WOKINGHAM BOROUGH COUNCIL

TREE PRESERVATION ORDER NUMBER: 789/1996

APPLICATION NUMBER: 242894

SITE ADDRESS: 1 BADGERS SETT, CROWTHORNE, WOKINGHAM, BERKS, RG45 6EY

Fig. 1: Level monitoring data points 1-5.

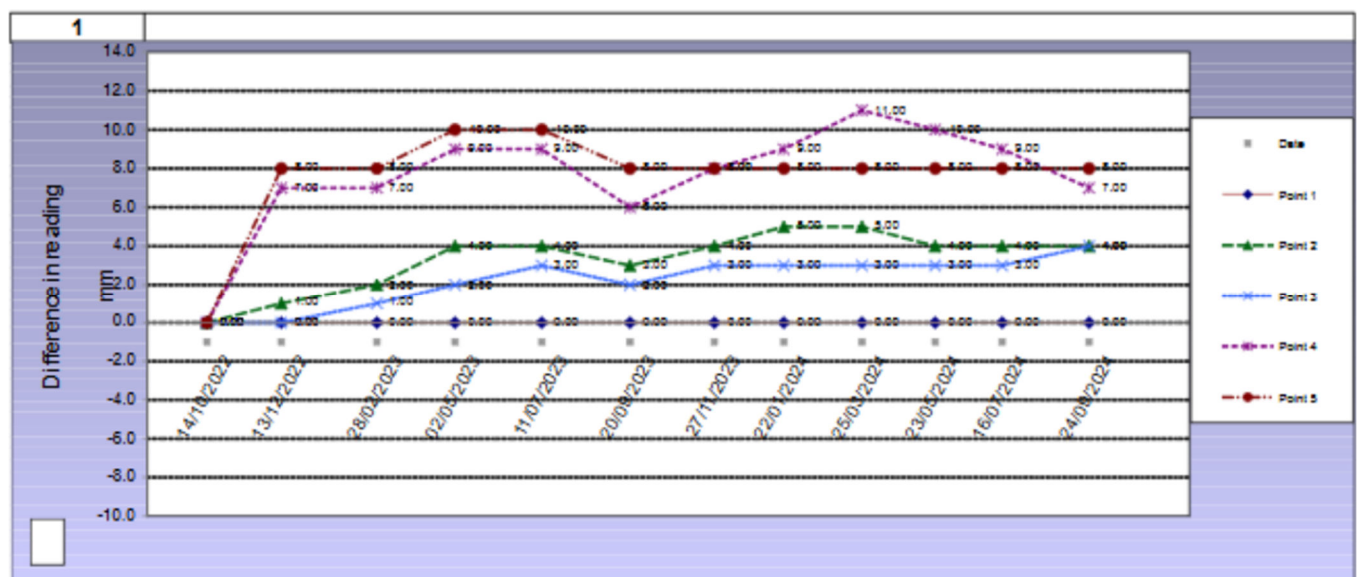
The statements above are incorrect, Fig 1. below from this report does not show any level monitoring during summer 2022 as it starts in October 2022 and shows an apparent 7 or 8mm initial rise in ground levels in late 2022 with further rising in the summer months leading up to July 2023. The pattern then follows what could be described as consistent with seasonal movement but from an elevated position with another rise in levels again leading up to March 2024, which shows all level readings remaining above the initial reading. This irregularity has not been explained.
